IREDELL COUNTY HEALTH DEPARTMENT

Re: Application for improvement permit for **Lonnie Troutman,** property site **156 Adkins Ln,** Health Department file number **203055**

Based on the criteria set out in Title 15A, Subchapter 18A, of the North Carolina Administrative Code, Rule .1940 through .1948, the evaluation indicated that the site is UNSUITABLE for a ground absorption sewage system. Therefore, your request for an improvement permit is DENIED. A copy of the site evaluation is enclosed. The site is unsuitable based on the following:

SOIL/SITE EVALUATION
for ON-SITE WASTEWATER SYSTEM

Sheet 1 of 2

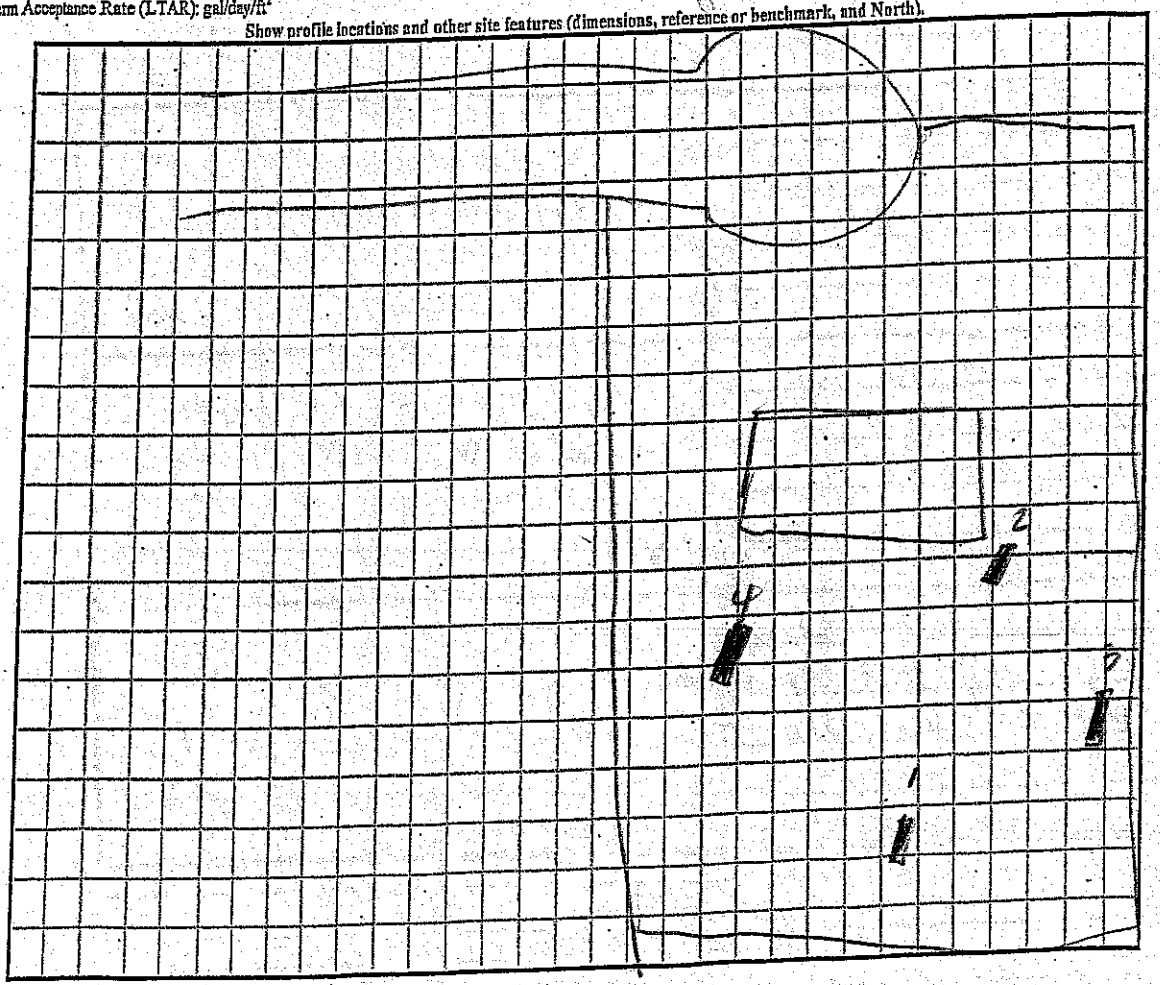
PROFILE #	.1940 LANDSCAPE POSITION/ SLOPE %	HORIZON DEPTH (IN.)	SOIL MORPHOLOGY (.1941) .1941 STRUCTURE/ TEXTURE	.1941 CONSISTENCE/ MINERALOGY	OTHER PROFILE FACTORS .1942 SOIL WETNESS/ COLOR	.1943 SOIL DEPTH	.1956 SAPRO CLASS	.1944 RESTR HORIZ	PROFILE CLASS & LTAR
1		0-8	BSCL fr	Gr SE	20"	>48"	>48"	20"	PS 0.1 DMP
		8-28	C fi	ABK SE					
		28-48	C+Sap Li	ABK SE	20-48" 7.5YR 8/2				
2		0-11	CL fr	SBK SE	23"	>54"	>54"	23"	PS 0.1 DMP
		11-23	C fi	ABK SE					
		23-54	BC fi	WABK SE	23-54" 7.5YR 7/2				
3		0-26	SCL fr	ABK SE	48"	>48"	>48"	48"	PS 0.2
		25-38	C fi	ABK SE					
		38-48	BC fi/fr	ABK SE	Chroma 2" @ 48"				
4		0-6	SCL fr	Gr SE	24" Exp	>48"	>48"	24"	PS 0.1 DMP
		8-28	C fi	ABK SE/E	28" Chroma 2's				
		28-48	BC fi/fr	ABK SE/E

COMMENTS: IP on Lot would be Limited to 3 BR

only
